# Value Engineering Study

Final Report

## Hal Rogers Parkway KY 30 to KY 192 (MP 1.089 to MP 3.877) Laurel County Item No. 11-365.00

May 25, 2022

VALUE ENGINEERING (VE) PROPOSAL NO. 09

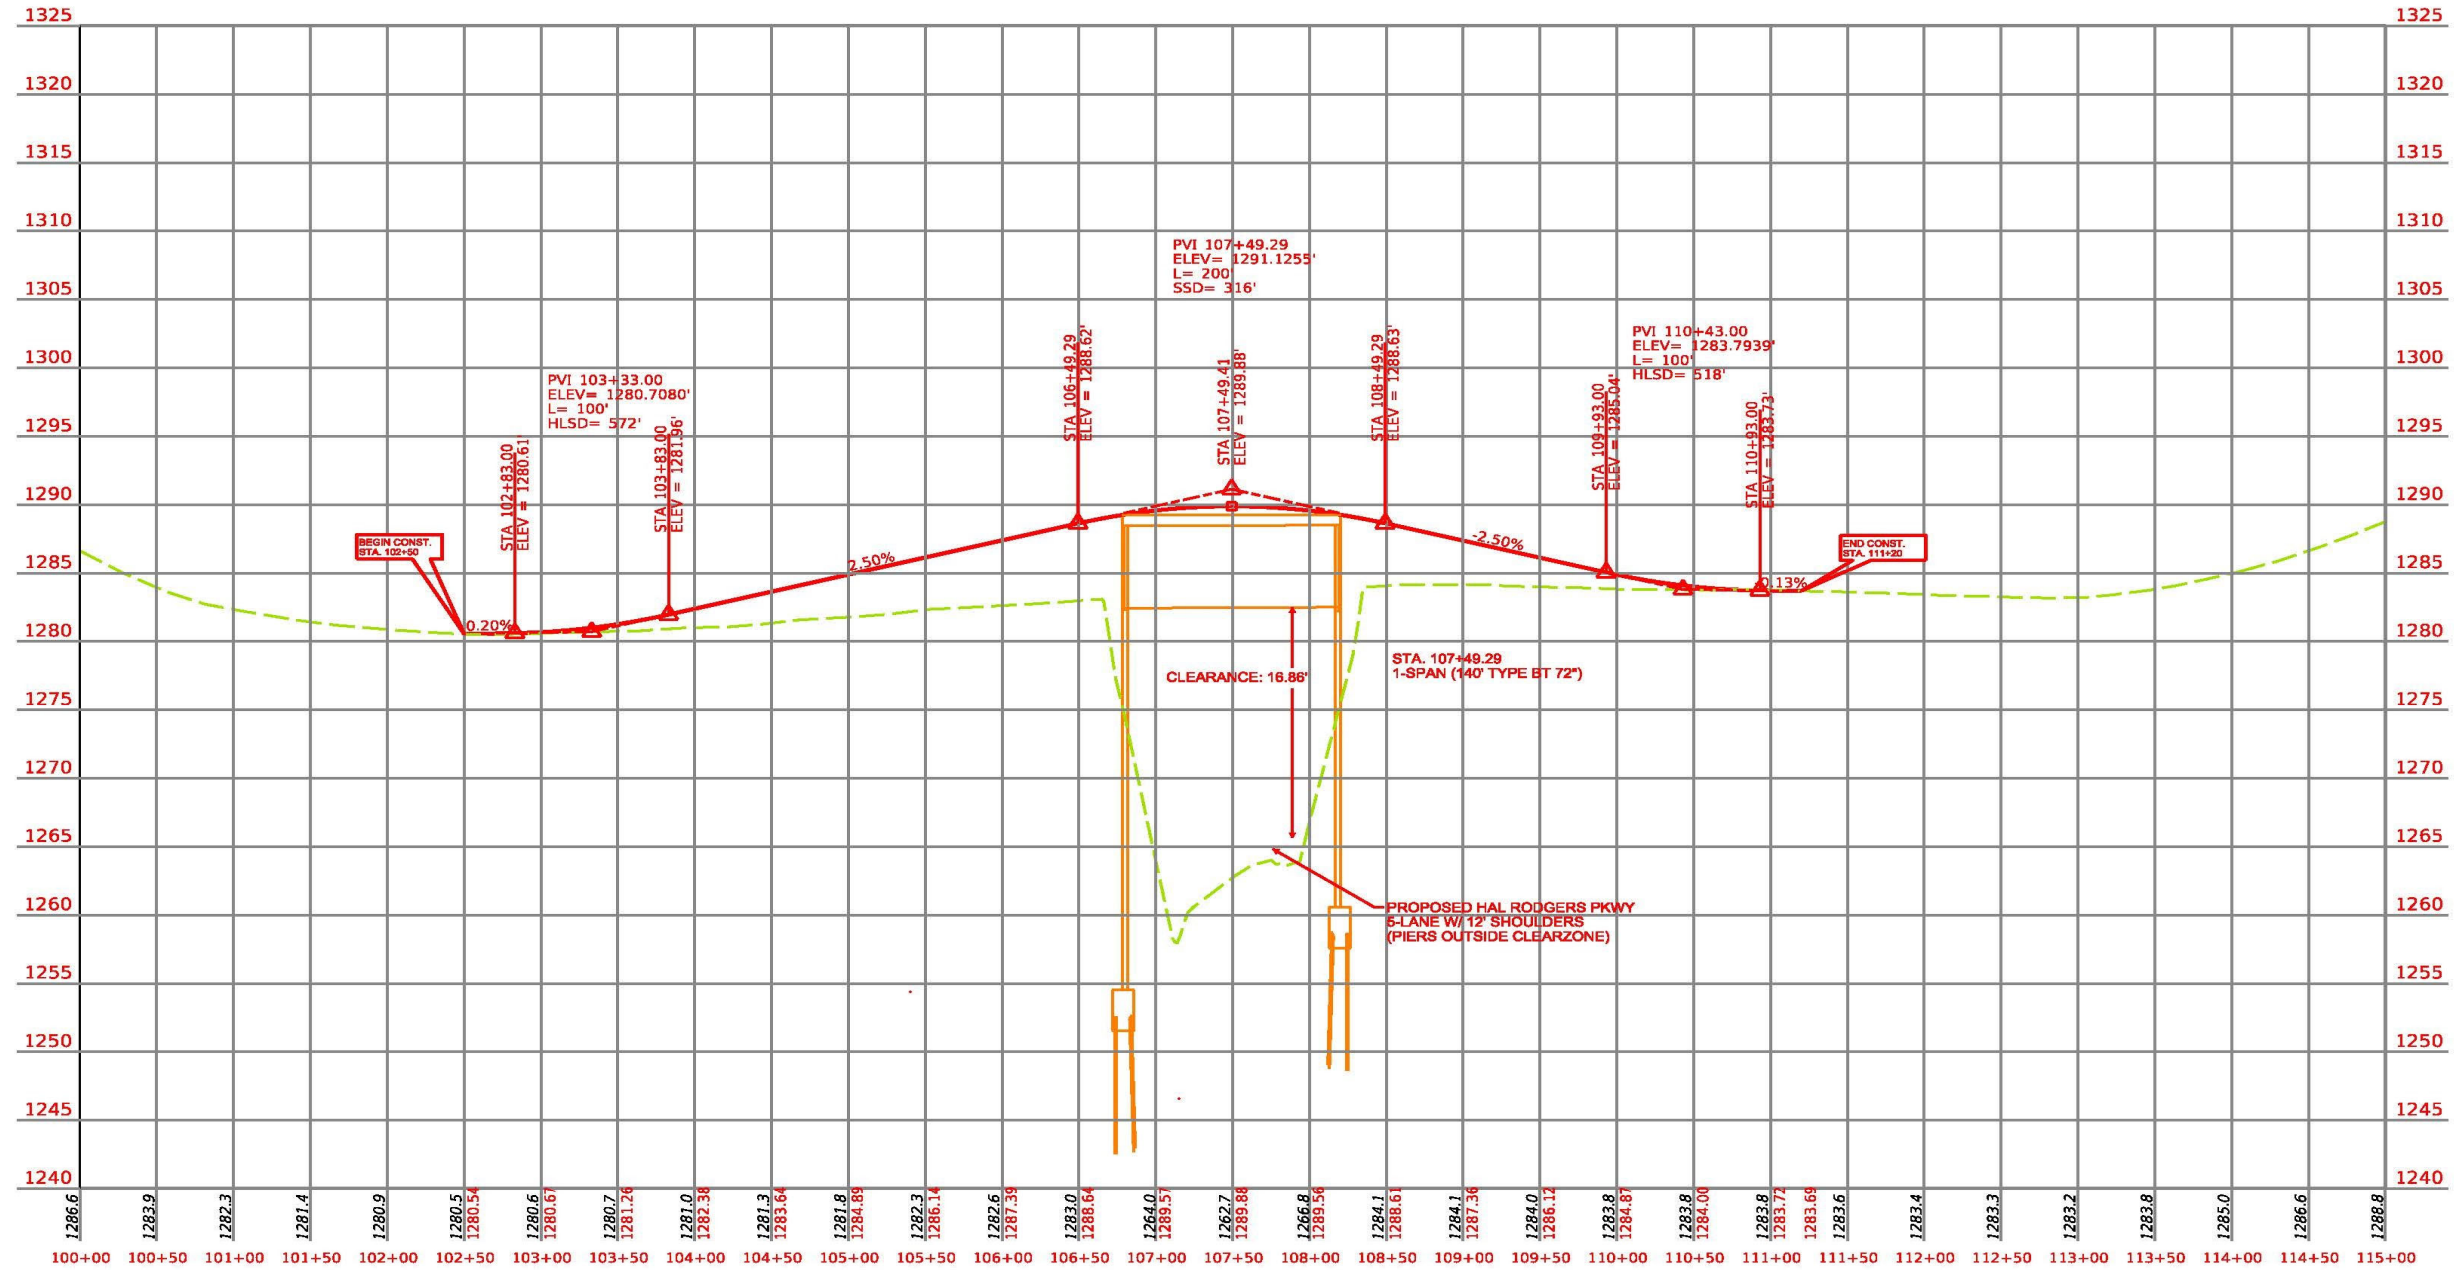
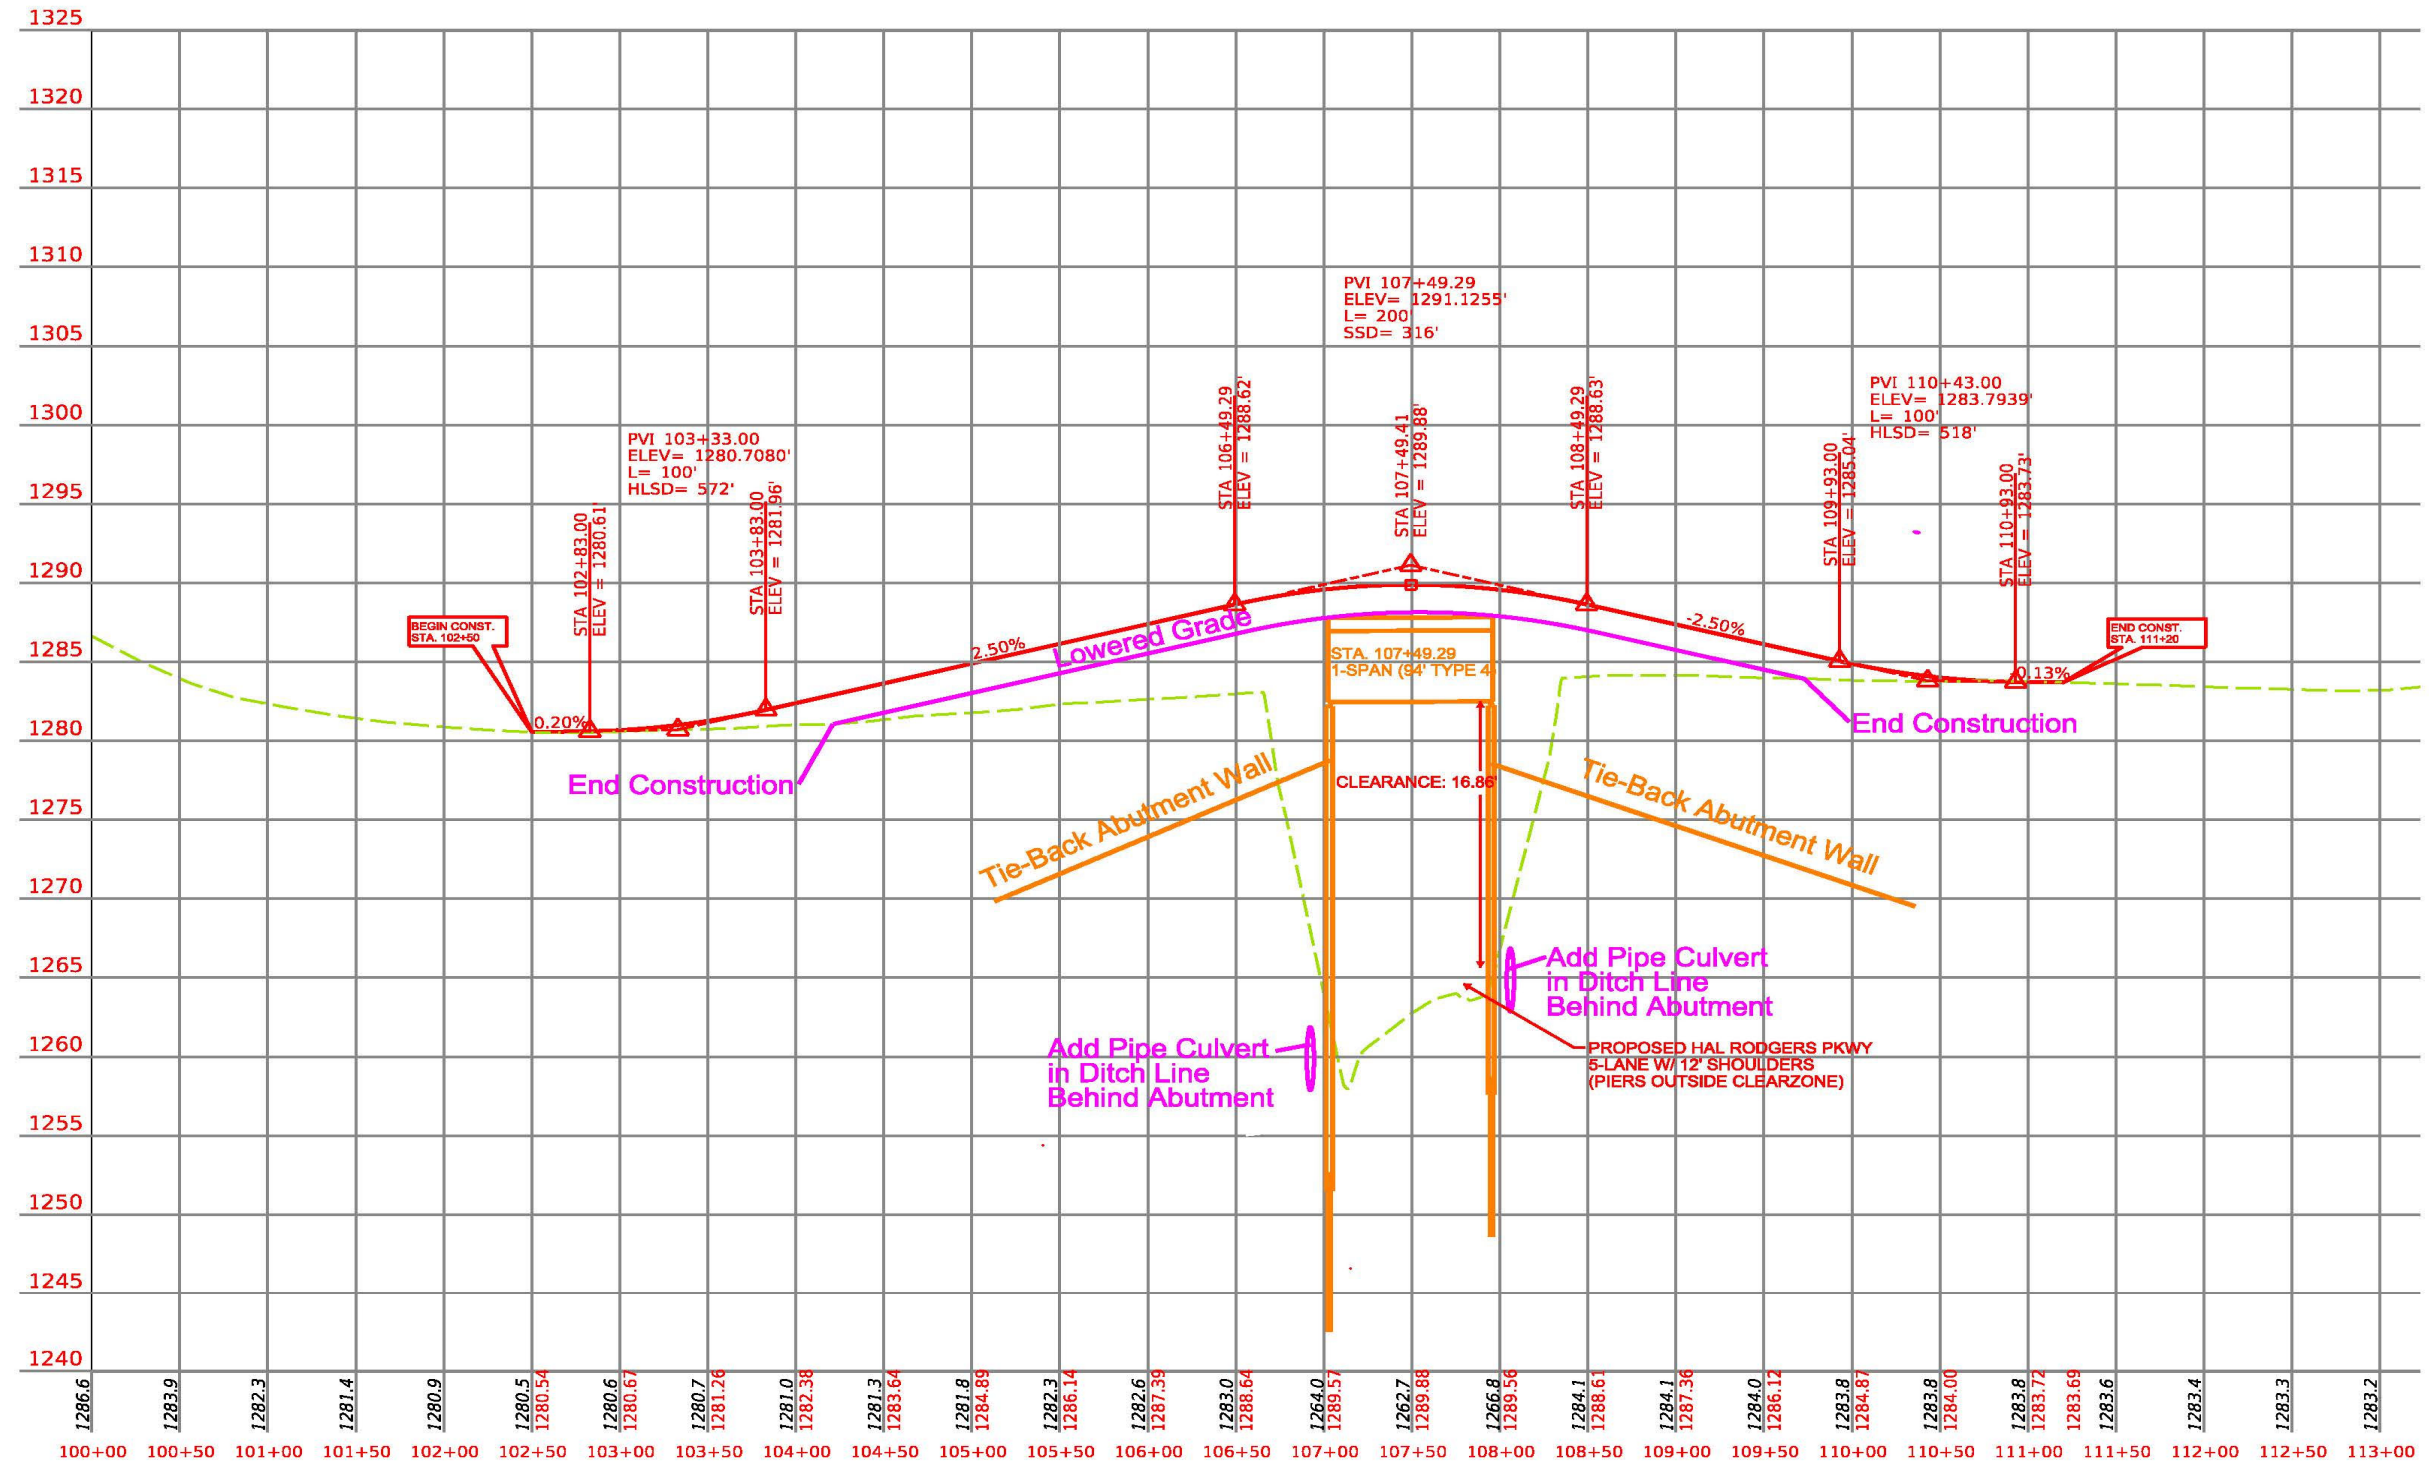
TITLE Construct Slate Lick bridge as a 94-foot single span bridge with full height abutments using tie backs

**VALUE ENGINEERING (VE) PROPOSAL NO. 10**

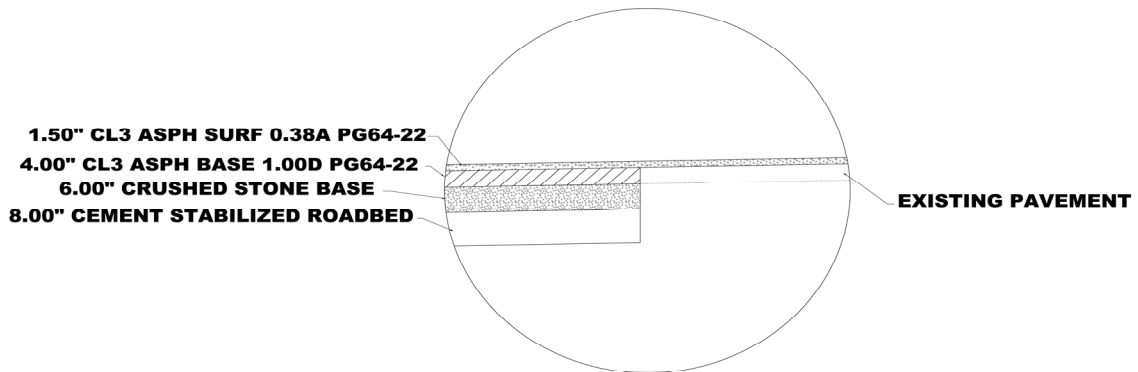
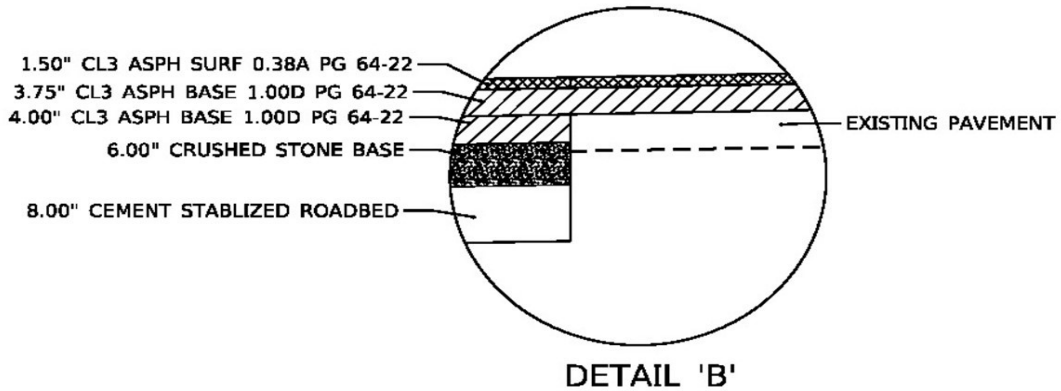
<b>TITLE</b>	Remove the asphalt base layer from the overlay of the existing pavement		
<b>FUNCTION</b>	<b>Support Load</b>		
<b>VALUE PROPOSAL SYNOPSIS:</b>			
This proposal is to remove the 3.75 inch asphalt base layer with the 1.5 inch asphalt surface pavement overlay.			
 <b>Reliability</b>	Maintained	 <b>Functionality</b>	Maintained
 <b>O&amp;M</b>	Degraded	 <b>Schedule Impact</b>	Improved
			<b>\$ Initial Cost Avoidance (Add)</b>
			<b>\$857,000</b>
<b>BASELINE CONCEPT:</b>			
The baseline concept includes a 3.75 inch asphalt base layer with a 1.5 inch asphalt surface for the overlay of existing pavement.			
<b>VE PROPOSAL DESCRIPTION:</b>			
Remove the 3.75 inch asphalt base layer from the existing pavement overlay.			
<b>ADVANTAGES:</b>		<b>DISADVANTAGES:</b>	
● Reduces cost		● Potentially an increase in future maintenance cost	
● Reduces construction time		●	
●		●	
●		●	
<b>OVERALL PERFORMANCE SCORE</b>			<b>-0.1</b>

<b>TITLE</b>	Remove the asphalt base layer from the overlay of the existing pavement
<b>DISCUSSION &amp; JUSTIFICATION:</b>	
<p>The proposed typical section includes a 3.75 inch asphalt base layer for the existing 1.5 inch asphalt surface pavement overlay. This value engineering concept is to remove the 3.75 inch asphalt base layer to the overlay pavement design. This recommendation stems from the project team explaining during the information phase that the existing pavement appears to be in good condition. With additional through lanes proposed in the baseline, the amount of traffic per lane will be reduced which is why the VE Team believes that the additional pavement layer may be unnecessary. Pavement cores should be obtained prior to making a final decision on the pavement design to verify if the additional base layer is necessary.</p> <p>The benefit of this alternate is that you reduce pavement cost and slightly reduce the construction schedule. The removal of the 3.75 inch asphalt base layer reduces the cost by \$857,000. The disadvantage of this alternative would be additional maintenance costs in the future if the pavement does not provide adequate structural support. This would be verified with core samples of the existing pavement. The VE Team agrees that if the core samples show that the additional base layer is needed for structural support then it should be constructed.</p>

VALUE ENGINEERING (VE) PROPOSAL NO. 11

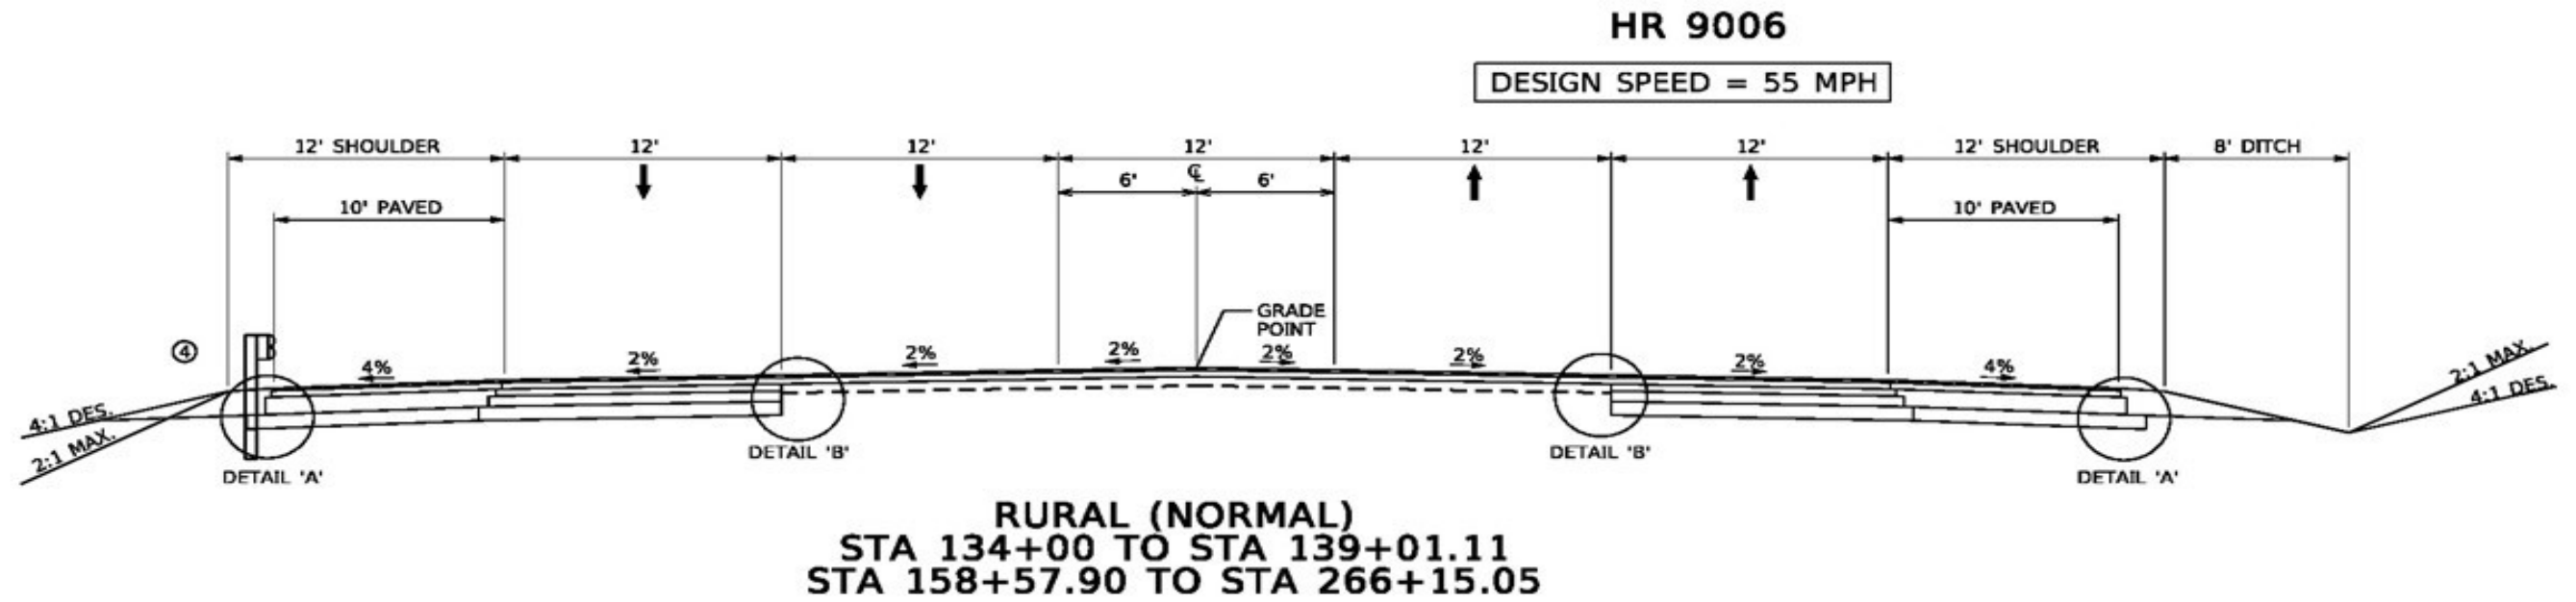
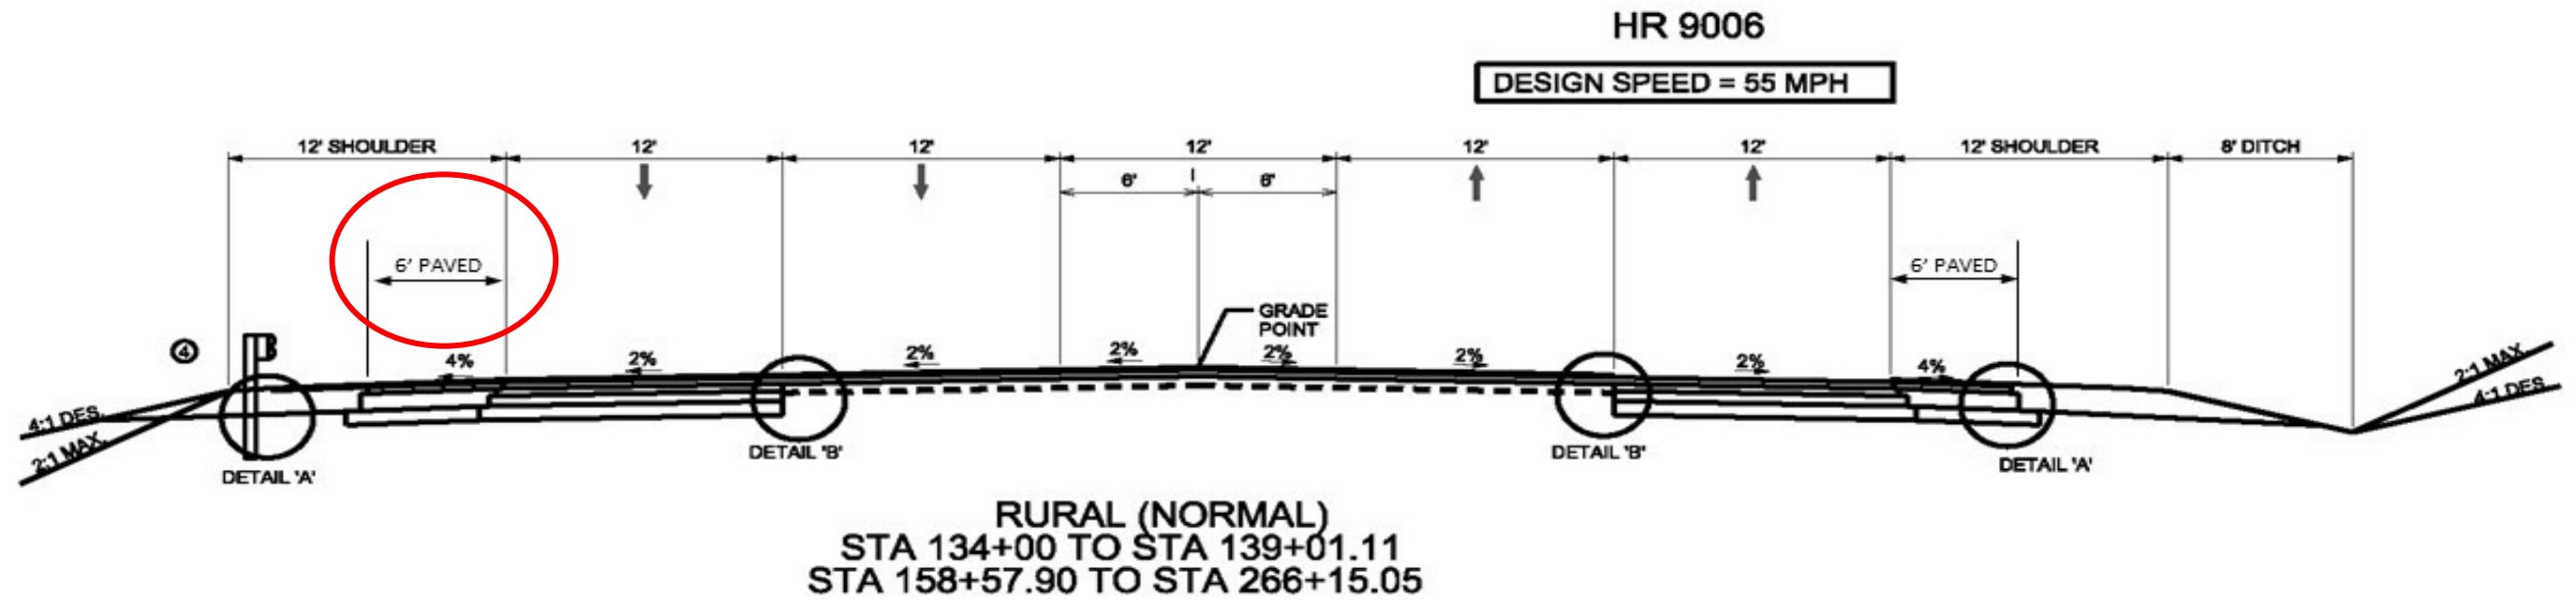
<b>TITLE</b>	Modify typical section to use 6' paved shoulders in lieu of 10'		
<b>FUNCTION</b>	<b>Support Load</b>		
<b>VALUE PROPOSAL SYNOPSIS:</b>			
Use a 6-foot paved shoulder with the baseline 12-foot usable shoulder. This option reduces cost without sacrificing operations of the facility.			
 <b>Reliability</b>	Maintained	 <b>Functionality</b>	Maintained
 <b>O&amp;M</b>	Maintained	 <b>Schedule Impact</b>	Maintained
			<b>\$ Initial Cost Avoidance (Add)</b>
			<b>\$350,000</b>
<b>BASELINE CONCEPT:</b>			
The baseline Hal Rogers typical section includes a 12-foot shoulder with 10 feet paved.			
<b>VE PROPOSAL DESCRIPTION:</b>			
The proposed typical section is a 12-foot shoulder with 6 feet paved.			
<b>ADVANTAGES:</b>		<b>DISADVANTAGES:</b>	
● Lowers initial cost		● Less paved shoulder for semi pull-off	
● Less pavement maintenance cost		● More shoulder maintenance cost	
●		● Loss of potential use of right turns off of shoulder
